Lotis Wellington (Medical Office Buildings 8 & 9)

STAFF REPORT

Petition Number: 2022-0006-ARB

Architectural Review Board approval of the commercial pod medical office buildings and wall signage for the approved Lotis Wellington 64-acre mixed-use project.

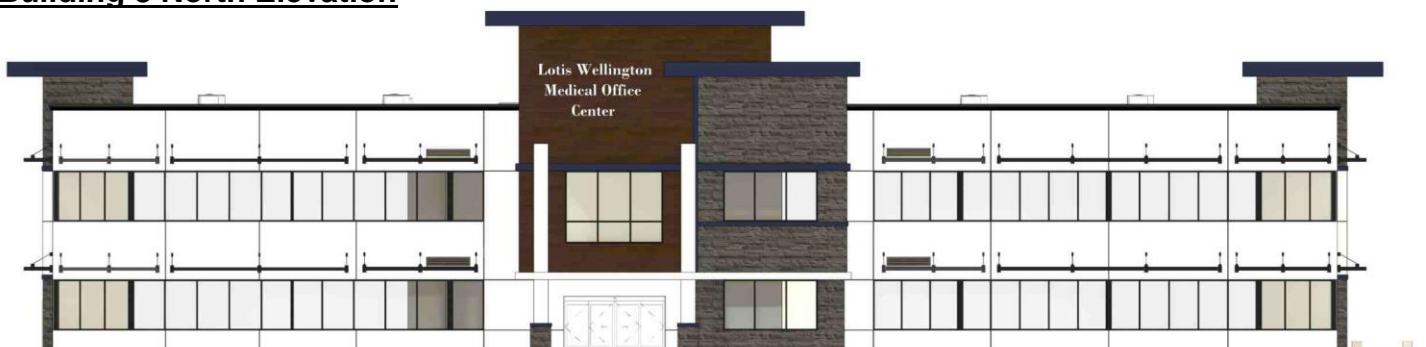
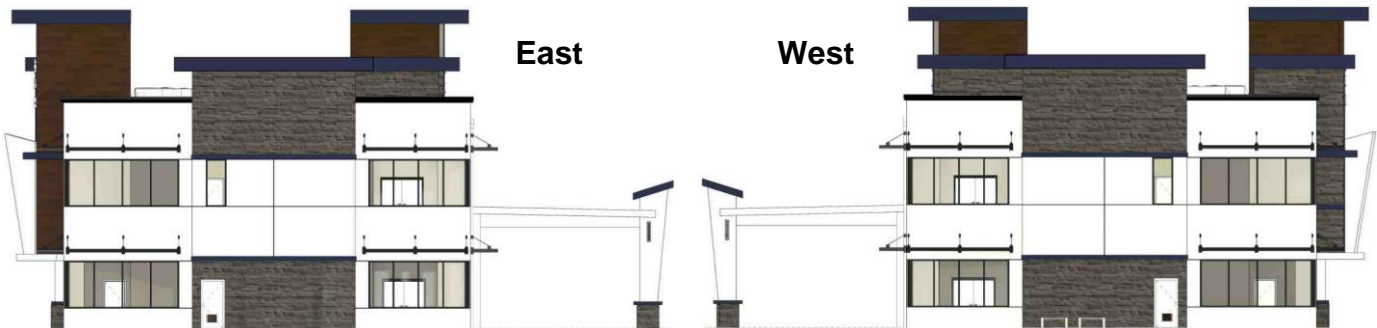
The renderings/elevations of the proposed two (2) MOB are provided as Exhibit B, the drawings illustrates two (2)-story buildings with an overall building parapet wall height of 34 feet, the tower/enter features parapet wall heights at 40 and 47 feet, and an overall length of 179 feet 11 inches on the south principal/main façade. The architectural details for the proposed buildings include stucco finish, decorative trim/band, accent stone/brick, aluminum awnings/canopy overhangs, and other architectural details as illustrated on the architectural rendering/elevation drawings Exhibit B and below for MOB 8 and 9.

As illustrated on the above drawings, both buildings are identical with only the mirroring of elevations between Building 8 and 9. These buildings are centrally located within the Lotis project just north of the approved parking garage, south of the multi-family residential buildings, and west of the combined retail/restaurant/office buildings. The design of the proposed buildings help ensure compatible with the character, mass, bulk, and scale of the surrounding area. The building's façade have a minimum depth of three (3) feet, with a repeating pattern, and includes design elements that repeat horizontally and vertically, as required for multi-family residential and non-residential buildings.

1. Elevations and architectural details for Buildings (Medical Office Building-MOB) 8 and 9 shall be consistent with Exhibit B.

Colors – Buildings 8 and 9

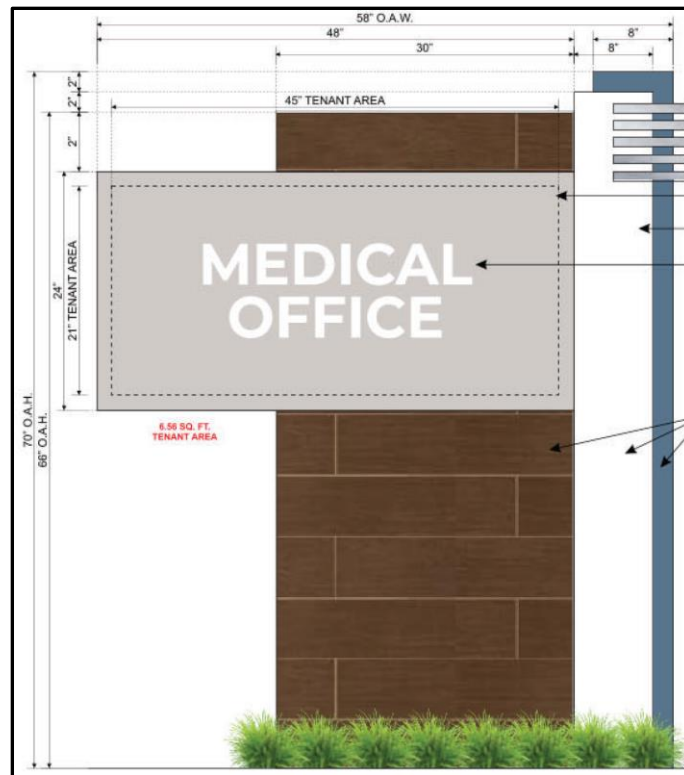
The proposed exterior color/material palette (Exhibit C) was reviewed for consistent/compatibility with the surrounding area, Wellington's approved ARB Color Chart, and the overall approved color/material palette for the Lotis project. The proposed color palette scheme indicates white for the base, and blue accent color for the cantilever roof, eyebrow and trim with all finish non-gloss for both buildings. Similar to the other buildings within the Lotis project, the MOB will utilize walnut and light grey stone title cladding as accents. The awnings, wall louvers, parapet cap, and storefront window/door frame color is black. The window/door glass/glazing color will be a light grey tint. Below are the proposed exterior colors and materials palette that will be utilized for MOB within this project.

The window frame, fencing/railing, site furniture, trash receptacle, bike rack, site light fixtures, regulator signage, etc., will be finished in black color, which is approved throughout the project/site. The dumpster enclosure(s) for the MOB will be submitted separately for review and approval prior to building permits. The proposed colors and materials palette is similar to what is approved for the other buildings in both the commercial and residential pods of the Lotis project.

2. The exterior color (non-gloss finish) and material palette shall be consistent with Exhibit C and the color/material scheme details as provided on Exhibits B-C, and:

Technical Deviation

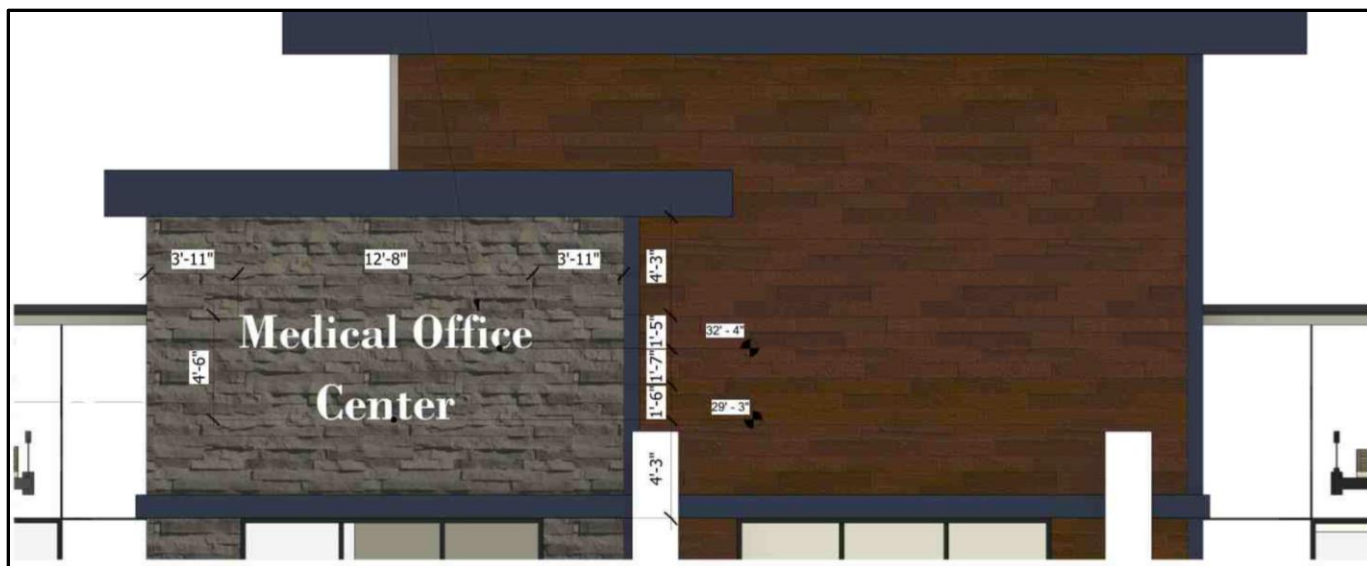
As indicated in the above table, the applicant is requesting Technical Deviation to exceed the maximum 50 percent sign area allowed for the secondary wall signs. The percent calculation for the secondary wall sign area is of the actual permitted/approved principal façade wall sign area, not per the maximum area calculation that may not be in proportion to the façade. An applicant may submit a request for a Technical Deviation for signs that do not meet the standards in the LDR, per the procedures and decision criteria provided in the Development Review Manual, as listed below:

The applicant is requesting deviation to allow two (2) secondary wall signs with an area of 57 square feet for each boxed sign area, which exceed the 50 percent sign area principal façade wall sign area allowed (49 sq. ft.) by eight (8) square feet.

The proposed secondary signs are not specifically prohibited and is permitted under LDR Sec. 7.9.7.A.1.d. Additional Wall Signs Allowed on Buildings. The applicant is only requesting ARB approval to deviate from the 50 percent sign area standard. The proposed buildings are within a 64-acre mixed-use project with other uses that includes restaurant, retail, independent living and assisted living facility, daycare, and greenway with a multi-use pathway open to the public. This minimal deviation will allow the proposed wall signs at 57 square feet each (boxed sign area), as illustrated below for the proposed secondary wall signs on the north façade/elevation for each the MOB.

As shown in the above illustration, the signs will be proportional to the area of the building it is attached. The proposed secondary wall signs are an appropriate scale, which will help with the overall building aesthetics of the north façade and provide visibility along the Lotis project main access drive.

- b) Buildings 8 and 9 principal and secondary wall signs are approved per below.

MOB 8 and 9 Secondary Wall Signs (North Façade/Elevation)		
Standards	Approved	Deviation
Number of Signs	1 (Each MOB)	0
Sign Area*	57 sq. ft.	8 sq. ft.
Height (Boxed)	54 in (4.5 ft.)	0
Length (Boxed)	152 in. (12.66 ft.)	0
